From: Steven Fairchild, HP ([steve.fairchild@hp.com](mailto:steve.fairchild@hp.com))  
 Date: 7 December 2004  
 Subject: SAS 1.1 External Connector Interoperability

**Figure 1, Plugfest Configuration**

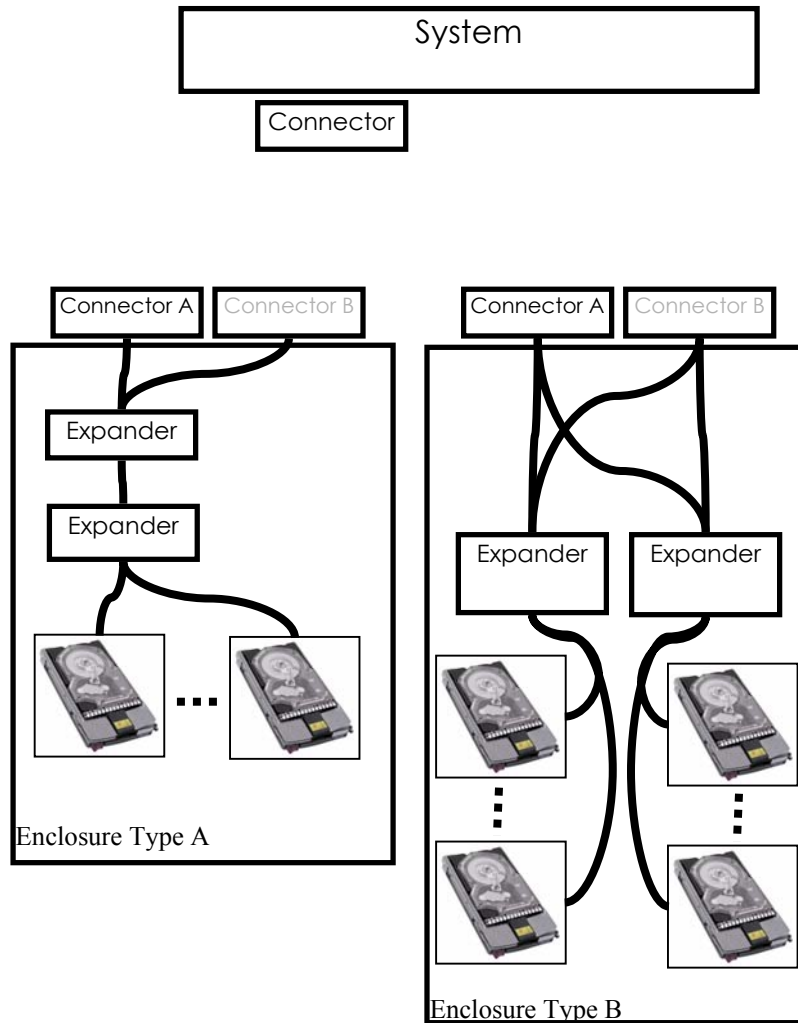
The first issue is an incompatibility that is created when phys routed to an external connector are attached to different expander and/or end devices within the enclosure (see Figure 1).

When the System connector was attached to either of the enclosures (from different manufacturers) the devices were properly discovered. Both enclosures were designed to be “daisy chained” to additional enclosures. When enclosures from the same manufacturer were

“daisy chained” (Enclosure type A to Enclosure type A or Enclosure type B to Enclosure type B) the topology was properly discovered. However when enclosures were “daisy chained” to each other (Enclosure Type A to Enclosure Type B or Enclosure Type B to Enclosure Type A) the topology was not properly discovered.

For “daisy chaining” to function, both enclosures defined one connector (assume Connector A for both enclosures) to use Table routing for the phys in the connector and one connector (assume Connector B for both enclosures) to use Subtractive routing for the phys in the connector. This allows the normal SAS routing behavior of chaining Table to Subtractive to create a large expander device set.

Enclosure Type A chose to attach all of the phys within each of its connectors to a single expander. Enclosure Type B chose to attach the phys within each of its connectors to multiple expanders. These two design choices are what caused the interoperability problem. When Enclosure Type A, Connector B is attached to Enclosure Type B, Connector A (Subtractive phys of Enclosure A to Table phys of Enclosure B) a conflict occurs because the expander attached to Enclosure Type A, Connector B has to different SAS Addresses attached to its Subtractive phys. This is an illegal routing configuration, because the expander attached to Enclosure Type A, Connector B cannot determine where to route its Subtractive addresses. Similar routing issues result from the different connection combinations (see Table 1).

From Table 1, the only legal connection Enclosure A, Connector A attached to Enclosure B, connector B had a problem due to a design decision based on the assumption that a connector would only present a single SAS address if it was attached to an expander.

To resolve this interoperability issue, HP would propose the following text (in blue) be incorporated in SAS 1.1 clause 5.2.3;

**5.2.3.x SAS external receptacle connector restrictions**

SAS devices using the external receptacle connector shall be attached to only one device type (i.e. end device type, edge expander device or fanout device).

SAS devices using the external receptacle connector attached to expanders shall be constrained to the following;

- a) An external receptacle connector shall be attached to only one expander device type (i.e. edge expander device, or fanout expander device), and
- b) An external receptacle connector shall be attached to only one expander device.
  - a. The expander phys contained within the external receptacle connector shall define a single port (ie. single SAS address),
  - b. The expander phys contained within the external receptacle connector shall have the same routing attribute (i.e. subtractive or table, but not both), and
  - c. The expander phys contained within the external receptacle connector that use the table routing attribute shall have the same number of route table entries.

SAS devices using the external receptacle connector may be attached to one or more end devices.

Figure L. 1, SAS Icon for Cables and End Devices

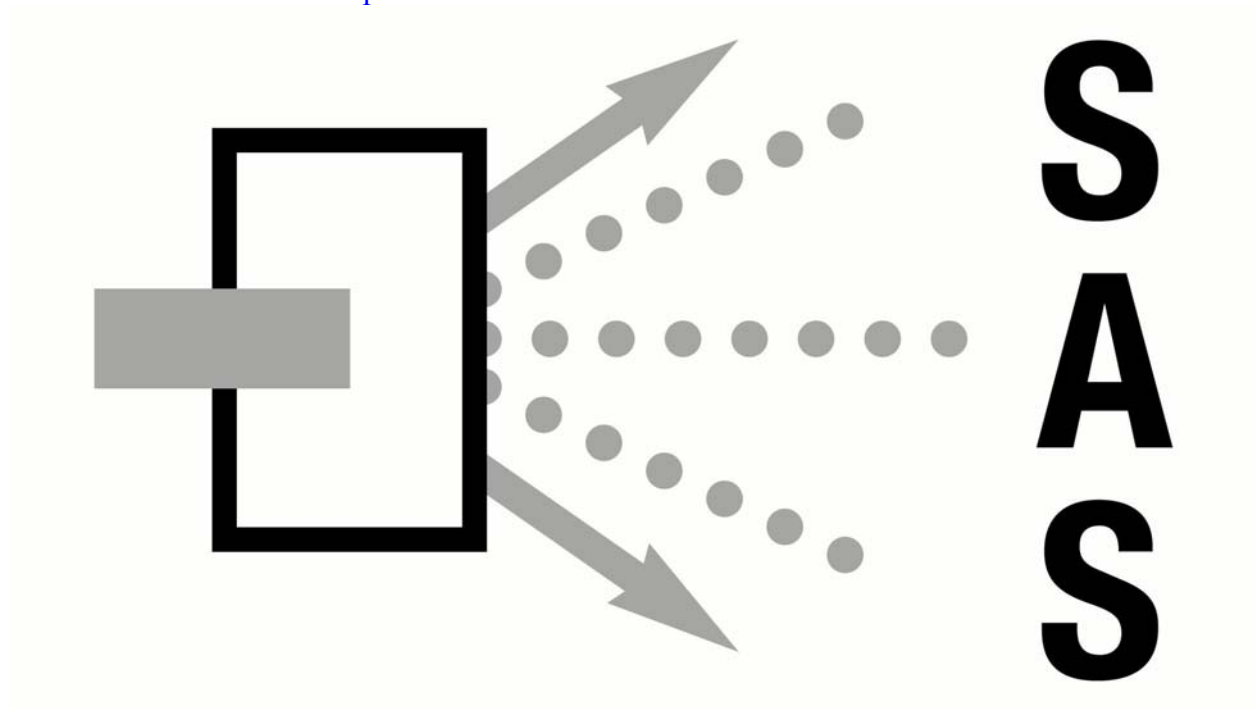
The second issue is a usability issue that occurs because it is difficult to describe how external connectors may be legally connected.

Using Figure 1 to illustrate the problem. During the plugfest there was no standardized way to reference Connector A and Connector B of each Enclosure. There was also no set of guidelines that described connectivity capabilities of an enclosure.

The remainder of this proposal recommends that a naming convention be provided for external connectors (including a set of icons) that provide guidelines for connectivity.

To resolve this issue, HP would propose the following text and graphics be incorporated in SAS 1.1 Annex L;

The SAS icons are shown in figure L1 to L3. One of these icons should be included on all connections to devices compliant with this standard.
